Coleman National Fish Hatchery Complex  
24411 Coleman Fish Hatchery Road  
Anderson, California 96007

On April 11, 2002 CALFED announced the initial funding recommendations for ecosystem restoration program proposals. The project entitled *Water Intake Screening and Intake Modifications at Coleman National Fish Hatchery* (Proposal No. 224) received the rating "Not Recommended for Funding." This particular project at the Coleman National Fish Hatchery (NFH) is located in a critical area (lower Battle Creek) and is associated (geographically) with a much larger investment in the Battle Creek watershed to restore natural populations of salmon and steelhead. The primary intent of the project is to avoid the impingement and/or entrainment of the naturally produced salmon and steelhead resulting from other restoration work within the system. The importance of this screening project has previously been identified in the Anadromous Fish Restoration Program Plan, and recognized by CALFED as a priority action associated with Battle Creek Restoration (Sacramento Region Priority Action #6; CALFED Draft Stage 1 Implementation Plan 2001). Therefore, we respectfully request CALFED's reconsidera

Figure 1. Existing water diversion and delivery system at Coleman National Fish Hatchery, Battle Creek, California.

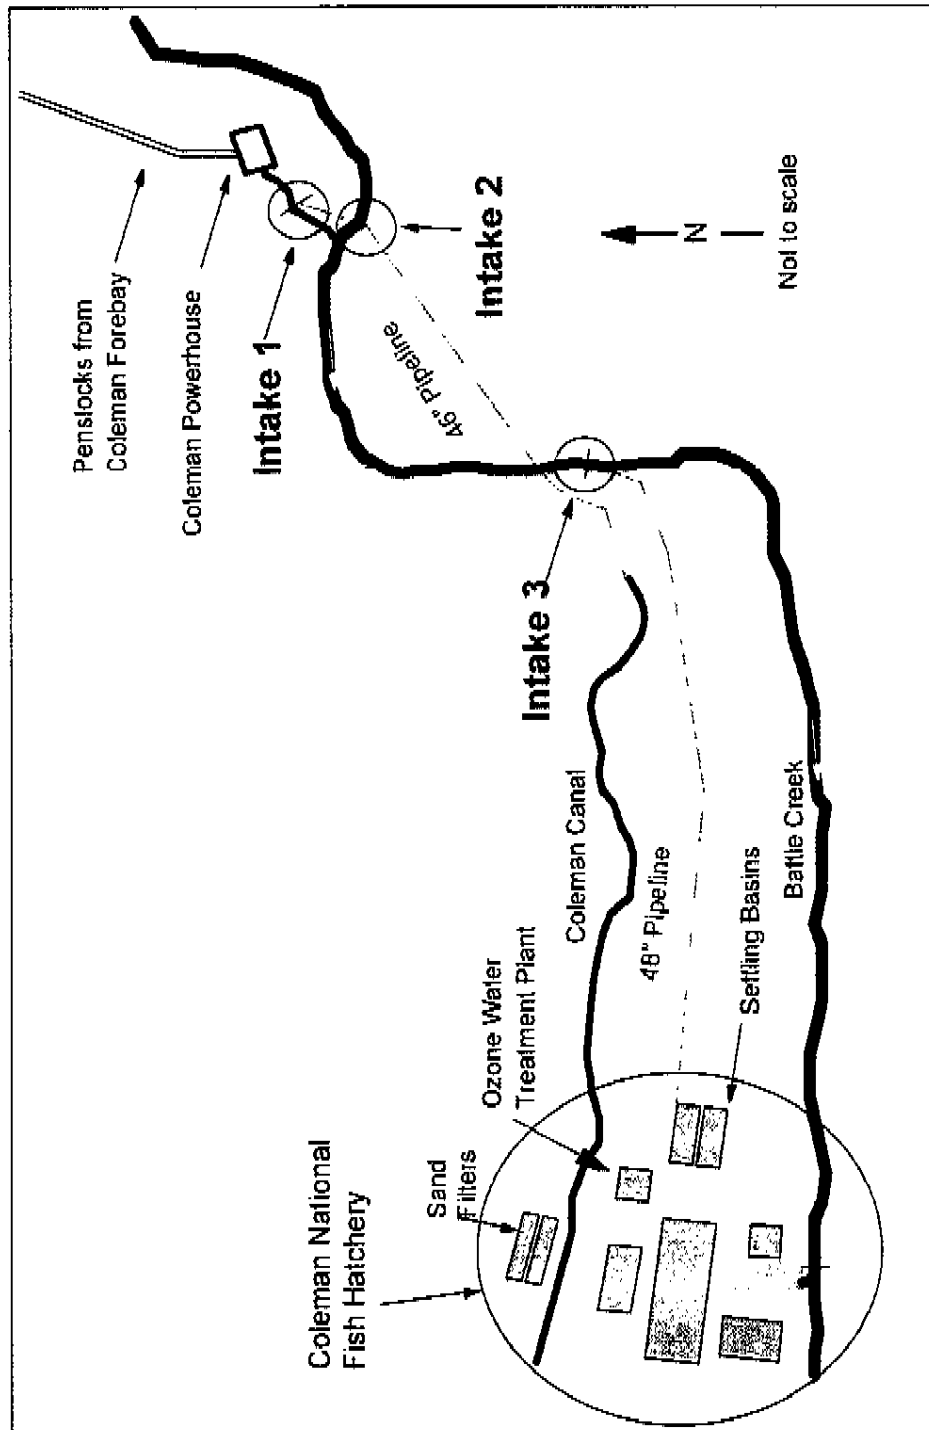
The Technical Review Panel suggested that Intake #3 water could be used exclusively during certain months (i.e., May and June) to meet hatchery water needs. Water is typically not available at Intake #1 in the Coleman Powerhouse tailrace during portions of these months, as cleaning and maintenance operations are occurring on the entire PG&E water conveyance system. The suggestion to use Intake #3 exclusively during this time was offered as a potential way to avoid using Intake #2 during this time period. Water quality issues aside, if the operational scenario suggested by the review panel were adopted, "flowing" water (from Intake #1 or Intake #2) would still be required in the Coleman Canal as the "emergency" water source. As described above, water from Intake #1 or Intake #2 must traverse a pipeline that is 2,700 feet long. Water then surfaces and is carried in the unlined Coleman Canal for an additional 3,900 feet. The Coleman Canal is estimated to be 10 feet wide and perhaps 5 to 6 feet deep, (the canal is actually trapezoidal in shape). Without adequate water flow through the canal, water quality quickly deteriorates (rapid plant growth and organic build-up, due to plant respiration and organic decomposition, and high temperatures). Although there are ways to discharge the canal water, rapid plant growth within the stagnant canal could overwhelm trash rack capabilities, and, especially in emergency situations, could become an unacceptably long process. Direct use of this stagnant water for fish production would also likely result in high mortality due to low dissolved oxygen levels and higher than tolerable water temperatures.

There are three water intakes at Coleman NFH identified as Intake #1, Intake #2 and Intake #3 (Figure 1). The hatchery's primary intake (Intake #1) is located in the tailrace of PG&E Coleman Powerhouse, on the north bank of Battle Creek. The tailrace empties into Battle Creek approximately 1.6 miles upstream of the hatchery property. Water taken through Intake #1 is conveyed to the hatchery through 2,700 feet of 46-inch diameter conveyance pipe, and then through 3,900 feet of open canal (Coleman Canal).

Coleman NFH Intake #2 is located on the south bank of Battle Creek, opposite of Intake #1. Intake #2 draws water directly from Battle Creek, and is used as an emergency back-up to Intake #1. The design of Intake #2 prevents diversion of water simultaneous with Intake #1 as Intake #2 shares the 46-inch conveyance pipe with Intake #1. Intake #2 supplies water to the hatchery only during periods when water cannot be supplied through Intake #1.

Intake #3 draws water directly from Battle Creek, approximately 0.4 miles downstream of Intake #2, and 1.2 miles upstream of the hatchery. Water diverted through Intake #3 is conveyed to the hatchery through 4,600 feet of 48-inch diameter pipeline.
